Project	IEEE 802.16 Broadband Wireless Access Working Group < http://ieee802.org/16 >
Title	Addition of Network Exit Procedure in Network Entry Management
Date Submitted	2007-01-12
Source(s)	Jee Hyeon Na, ETRI, E-mail: jhna@etri.re.kr Jaesun Cha, ETRI, E-mail : jscha@etri.re.kr JungMo Moon, PhD, ETRI, E-mail: jmmoon@etri.re.kr Mi-Young Yoon, ETRI, E-mail: myyun@etri.re.kr Sang Ho Lee, PhD, ETRI, E-mail: leesh@etri.re.kr Yun Won Chung, PhD, Soongsil University, E-mail: ywchung@ssu.ac.kr
Re:	Call for Comment on P802.16g D6 Document
Abstract	This contribution proposes service primitives for network entry.
Purpose	The document should be considered during the resolution of comments on the D6 document.
Notice	This document has been prepared to assist IEEE 802.16. It is offered as a basis for discussion and is not binding on the contributing individual(s) or organization(s). The material in this document is subject to change in form and content after further study. The contributor(s) reserve(s) the right to add, amend or withdraw material contained herein.

Addition of Network Exit procedure in Network Entry Management

Figure xxx – Network Deregistration Primitives by MS

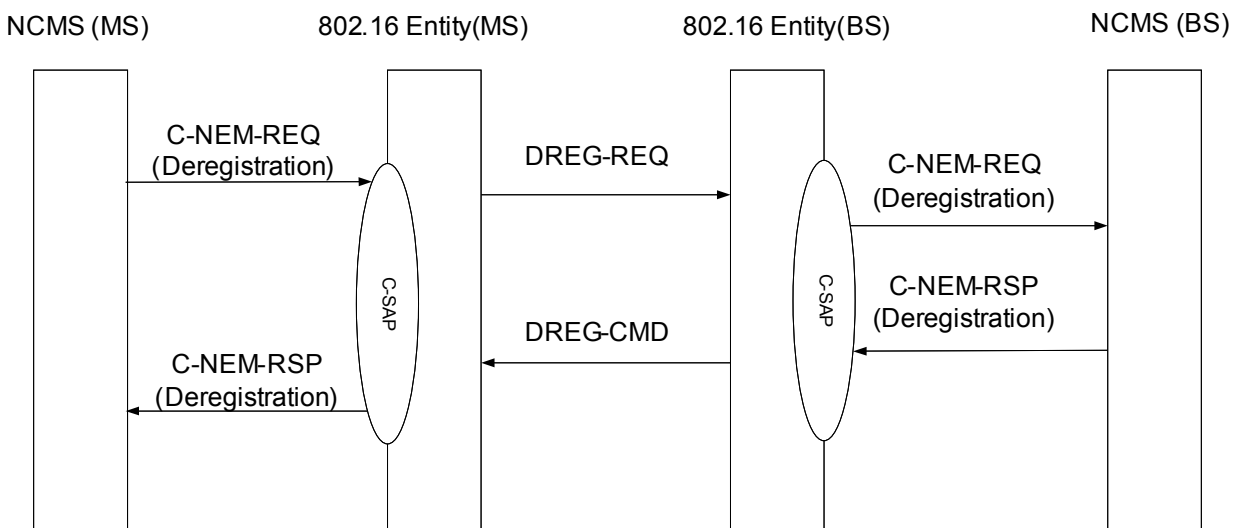
[Inserts the following after figure 500]
